Palo Verde Nuclear  
Generating Station

**Subject: Palo Verde Nuclear Generating Station (PVNGS)  
Unit 2  
Docket No. STN 50-529  
Request for a License Amendment to Support Replacement of Steam  
Generators and Upated Power Operations**

## **ATTACHMENT 2**

**MARKED-UP OPERATING LICENSE AND  
TECHNICAL SPECIFICATION PAGES**

Figure 3.4.1-1  
Reactor Coolant Cold Leg Temperature vs. Core Power Level

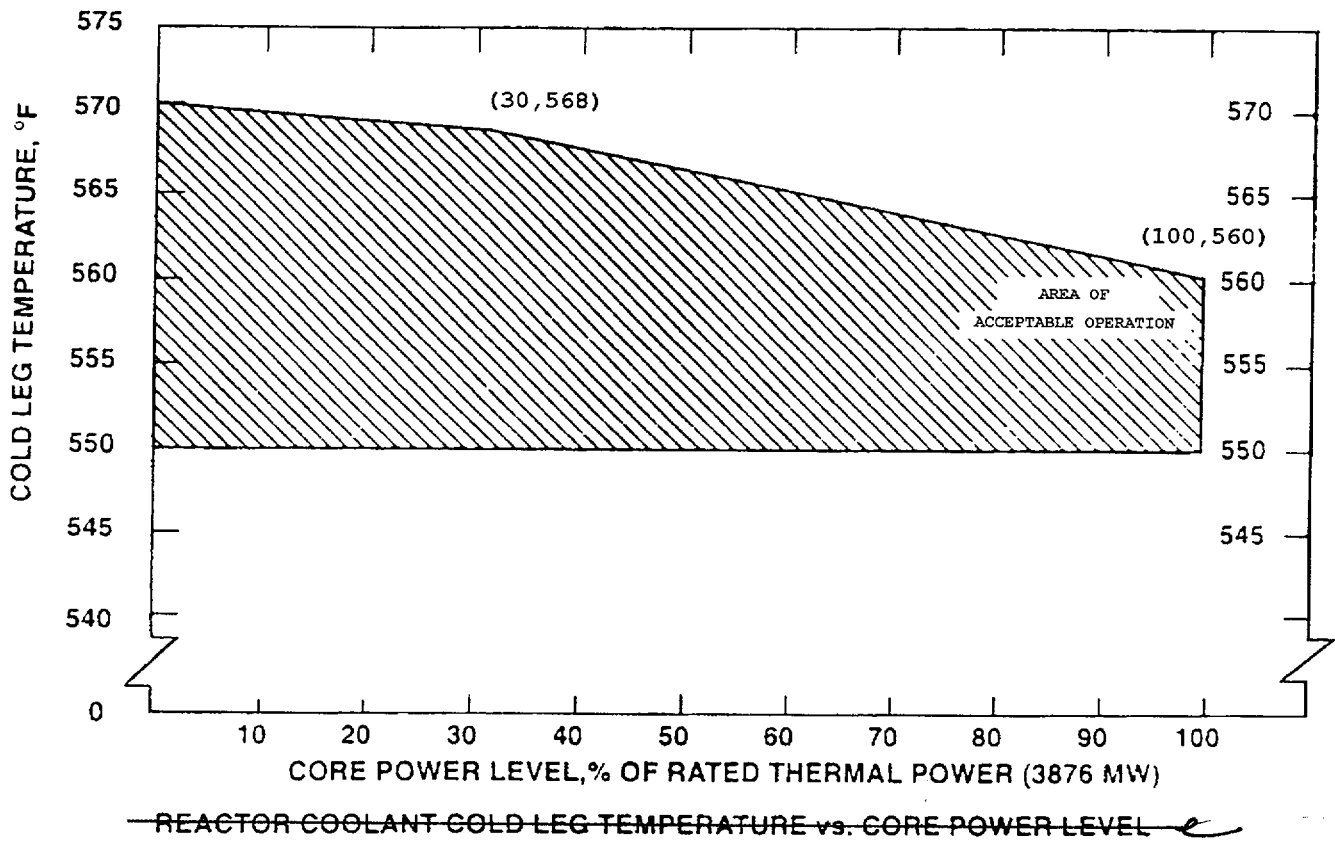
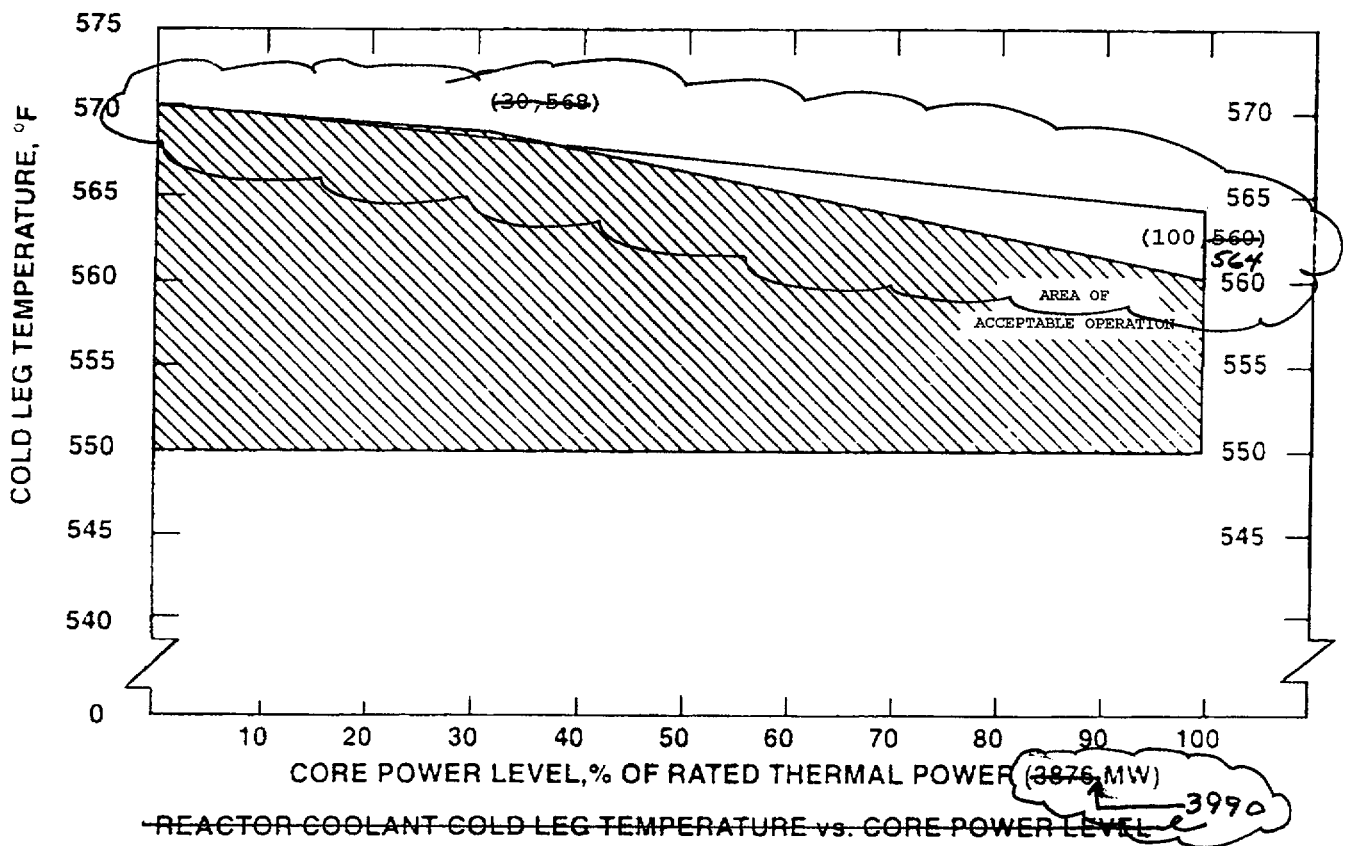
- F. Revise Figure 3.4.1-1, Reactor Coolant Cold Leg Temperature vs. Core Power Level, to change the upper limit in the area of acceptable operation for Unit 2. The new

upper limit line would allow a cold leg temperature of 570 °F at 0% power, decreasing linearly to 564 °F at 100% power. The upper limit line of Figure 3.4.1-1 in the current Technical Specification decreases linearly from 570 °F at 0% power to 568 °F at 30% power. At 30% power the current figure then decreases linearly from 568 °F to 560 °F at 100% power. The increase in cold leg temperature at 100% power will allow a more optimum main steam pressure for turbine operation. Additionally, editorial changes will be made to Figure 3.4.1-1 for Units 1 and 3. Both the power uprate and RSGs affect this specification.

Figure 3.4.1-1, Reactor Coolant Cold Leg temperature vs. Core Power Level, referenced in LCO 3.4.1, RCS Pressure, Temperature, and Flow Departure from Nucleate Boiling (DNB) Limits, provides parametric limits to ensure that the actual value of the reactor coolant cold leg temperature is maintained within the range of values used in the safety analysis. The safety analysis supporting this requested amendment uses the proposed new allowable cold leg temperature range (550 °F to 570 °F), and this proposed change maintains the basis for the cold leg temperature limits.
